NAPLES AIRPORT
RUNWAY 5/23 DRAINAGE IMPROVEMENTS, PHASE 3

ADDENDUM NUMBER TWO

April 20, 2022

4 SURFACE PAINTED HOLDING POSITION SIGN DETAILS
N.T.S.

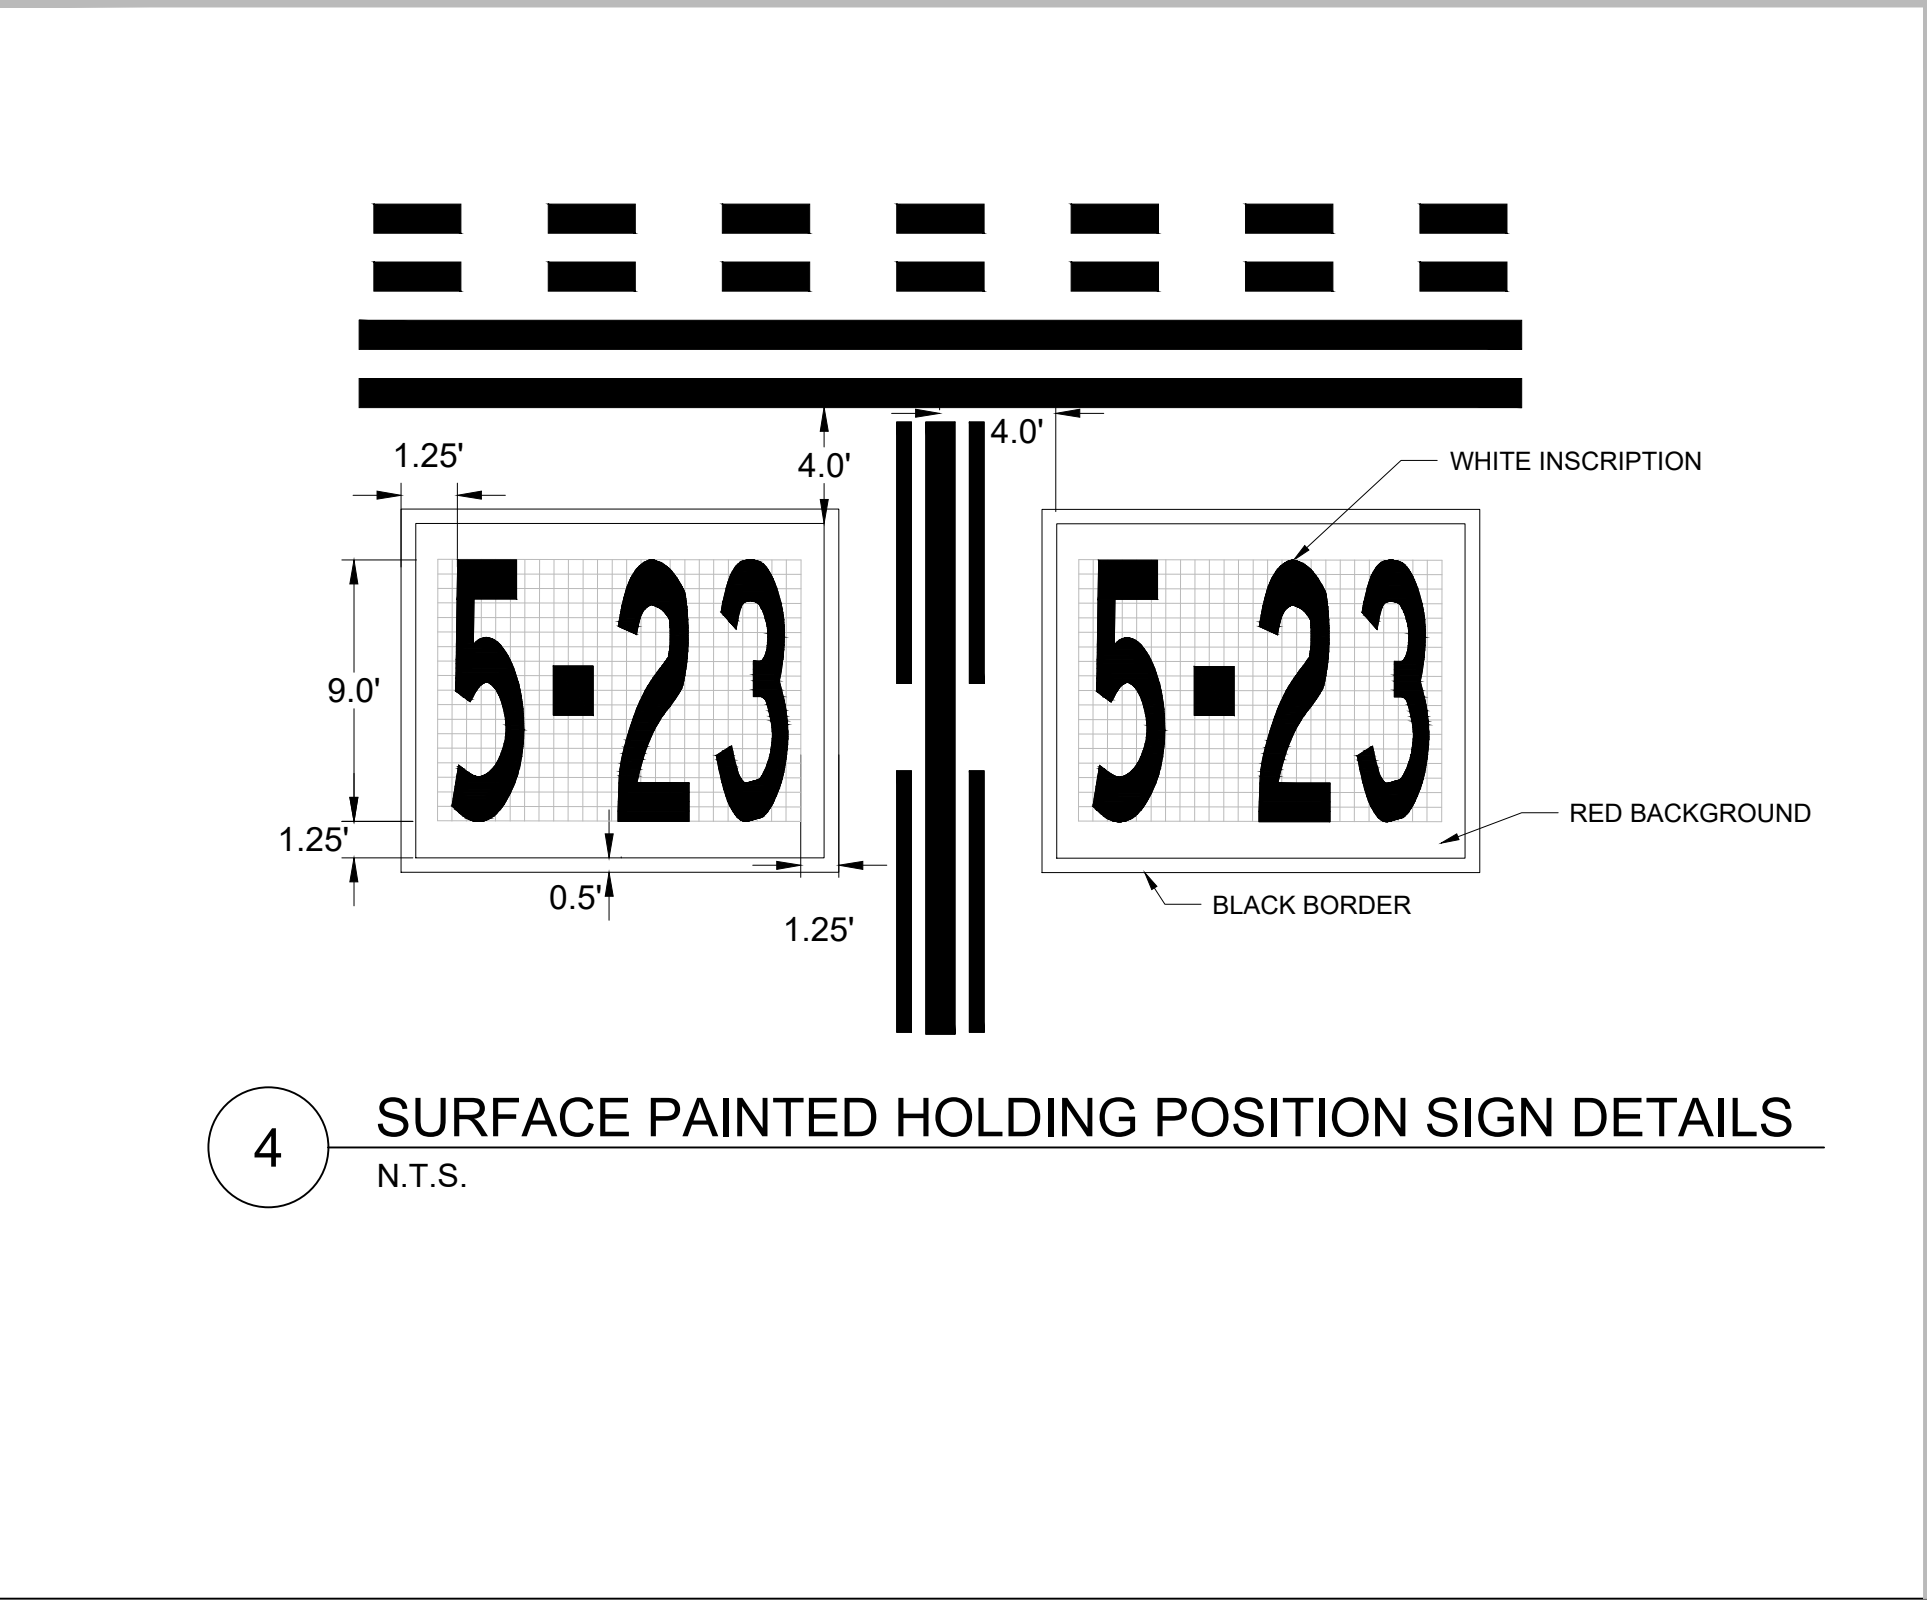
Question 3: Sheets C601 & C602 notes to 'Restore Asphalt Pavement and Repaint Taxiway Markings" at the proposed Taxiway pipe crossings. Details 3 & 4 on Sheet C404 appear to correlate with the notes on Sheets C601 & C602.

Answer: Sheet C603 Taxiway Marking Details has been added (see attached).
